*LUCAS COUNTY
PLAN COMMISSION
REPORT*

November 19, 2014

1. Z20-C967: Zone Change from A-3 to R-3 PUD at 9640 Sylvania-Metamora Road (jl)
2. Z20-C968: Zone Change from A-3 to R-3 PUD at 9330 Brint Road (jl)

PUD DRAWING

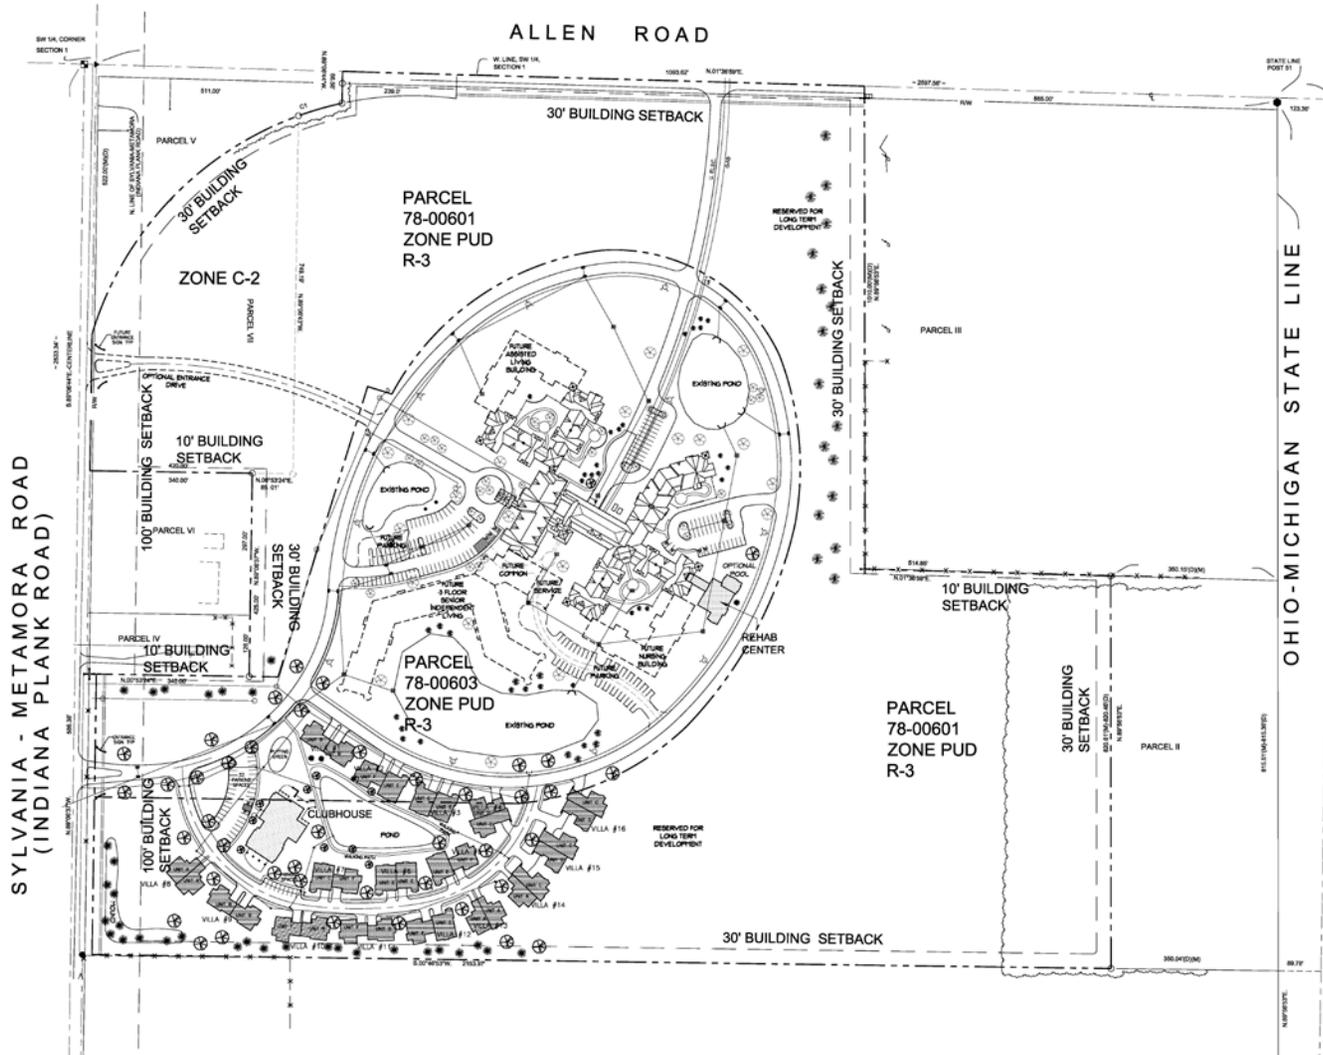
The proposed plan will add the rehabilitation center to the existing facility. The proposed clubhouse is 10,500 sq. ft. and will be located near proposed duplex units along the southeastern portion of the property. Individual duplex units will vary been 1,000 sq. ft. and 1,250 sq. ft and will be connected to the existing campus through a private drive. The plan also includes potential future additions for the campus. They include: a 16,000 sq. ft. nursing building, a 16,000 sq. ft. assisted living building, a 42,000 sq. ft. independent living building, a 8,000 sq ft. common space, and an additional entrance on Sylvania Metamora Road. Those are shown for references purposes only on the plan.

Parking requirements for the clubhouse are met by providing 42 space parking area and for the duplexes by providing individual drives with garages. Parking information was not provided for the rehabilitation center, although the architect indicated this addition will primarily serve residents of the facility. The rehabilitation center is not expected to increase parking because the facility will be used by onsite patients. Landscaping is provided along a portion of the eastern property line, but staff recommends this be extended further to the north to screen units from view and that fencing also be considered.

R-3 zoning is necessary in order to construct duplexes as part of the senior living project, however maximum density for this site is not supported. The plan submitted with the zone change request shows future expansions at the site. The PUD is included to limit the overall density of the project to levels consistent with nearby development. Duplexes and apartments are the only part of this project that counts towards density. On 72.2 acres, the 32 duplex units result in .44 units per acre. The density is below the maximum R-3 PUD density of 7 units per acre and surrounding residential developments with R-A or R-1 zoning.

The plan provides open space and coverage calculations for this project as well as potential future additions. A maximum of 40% of the site shall be devoted to coverage by buildings, structures, streets, driveways, or parking. Coverage is compliant at 16% of the total acreage. A minimum of 15% of the land shall be dedicated to useable, accessible, and consolidated open space. Open space is compliant at 17.3% of total acreage. The site provides proposed and existing ponds as well as walking trails.

- 25. Perimeter and rear yard drainage will be required in the rear yards of the proposed Villas along the easterly property line.

- 26. Landscaping shall be extended further north along the eastern perimeter of the site to fully screen the duplexes from view. Fencing should also be considered.
- 27. The "future buildings" and "future parking" will require review through the Planned Unit Development / Zone Change process at a later date.
- 28. Sidewalks should be installed along Sylvania Metamora Road for the area involved in the proposed development.

29. There are setback issues with the proposed clubhouse and duplexes. The two parcels shall be combined through the Lucas County Auditor's Office unless a waiver is approved by the township trustees per Sec. 2002.A.

SITE PLAN

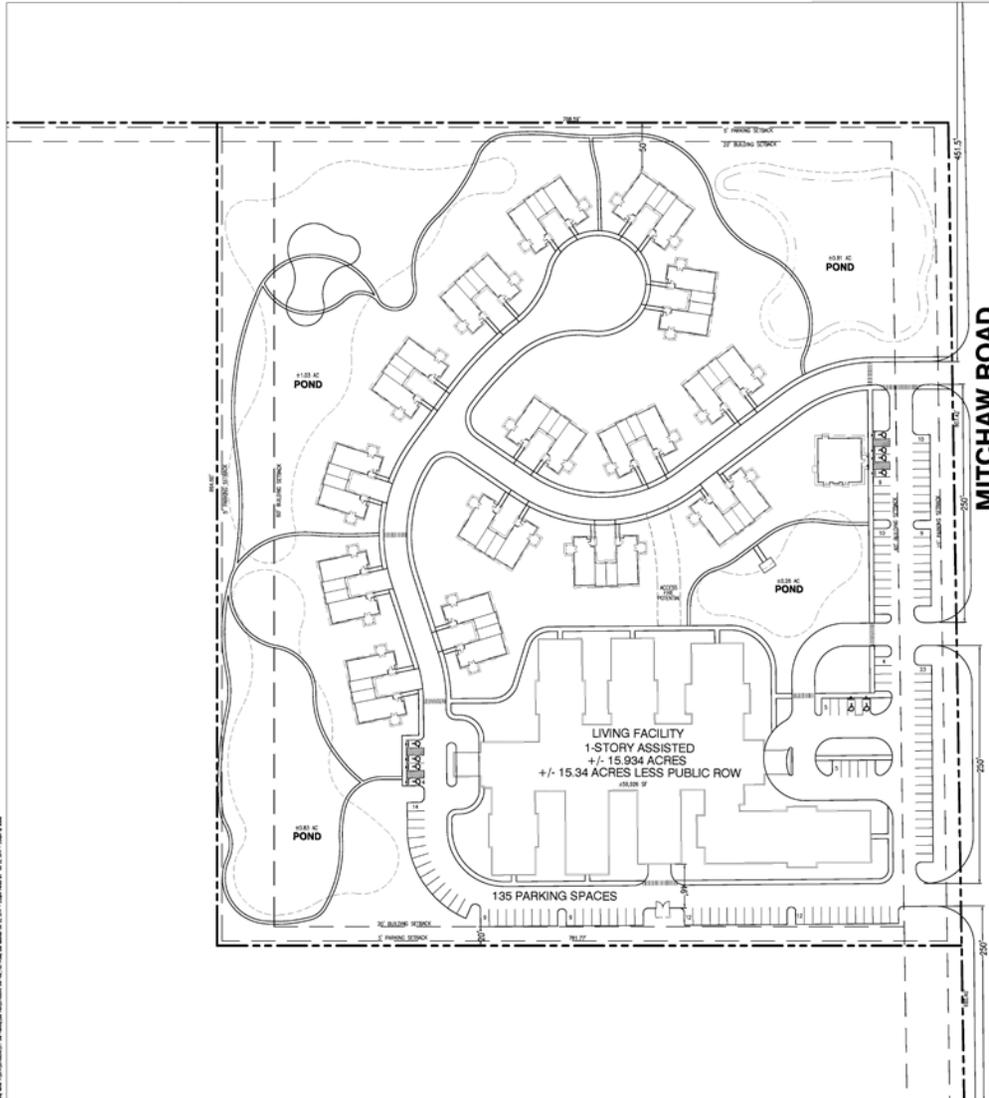
The plan indicates that the residential care facility will be 60,000 sq. ft. and limited to a single-story, while each individual duplex unit will be 1,536 sq. ft. The entire project will be contained on a single lot creating a campus feel. It will be accessed by private drives and connected with walking paths and ponds. The site meets parking requirements by providing a 135 space parking lot for the residential care facility and clubhouse, along with private driveways for each duplex unit (2 spaces per driveway). A landscape plan was not provided, but landscaping and screening is recommended along the perimeter of the parcel, especially to the north.

1. A landscape plan should be submitted as a requirement of the Planned Unit Development. Landscaping is recommended along the perimeter of the parcel, especially to the north.

24. The proposed access to Mitchaw Rd. shall follow the requirements of the Lucas County Access Management Regulations. An access permit application shall be submitted to the Lucas County Engineer's Office for review and approval.

25. The proposed driveways shall slope away from the Mitchaw Rd. pavement.
 26. Indicate driveway radii on the plan. Minimum radii of 25 feet is required.

30. The existing roadside ditch along Mitchaw Road shall be enclosed between the proposed driveways and catch basins provided at regular intervals.

31. A revised plan should be submitted indicating compliance with the 15% consolidated, useable, and accessible open space requirements.
32. A landscape plan shall be submitted to the township per the PUD requirements. Screening and landscaping along the perimeter of the parcel is encouraged, especially to the north.
33. Sidewalks should be installed along the Mitchaw Road frontage per Sylvania Township resolution 98-01-060.
